**CITY OF SAINT PAUL
HERITAGE PRESERVATION COMMISSION STAFF REPORT**

FILE NAME: 700 Fourth Street East – Edward McNammee House

CLASSIFICATION: Demolition Permit

Project No.: 15538.00
Re: Structural Condition Review of the building at 700 4th St. E.

Picture 5 – Bay at South Wall

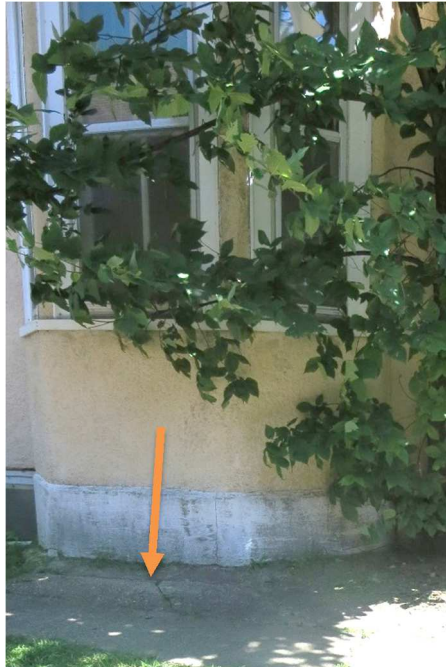
The bay along the south wall of the house appears to have settled. Picture 5 shows the bay and a crack that has occurred next to it. There is a tree that is growing just east of the bay. Its trunk is adjacent to the foundation wall. The tree is likely one cause of the settlement of the bay and could be the cause of other problems in the house. Picture 6 shows the base of the tree and the foundation wall. The background of Picture 4 shows the bay along with the tree as well.
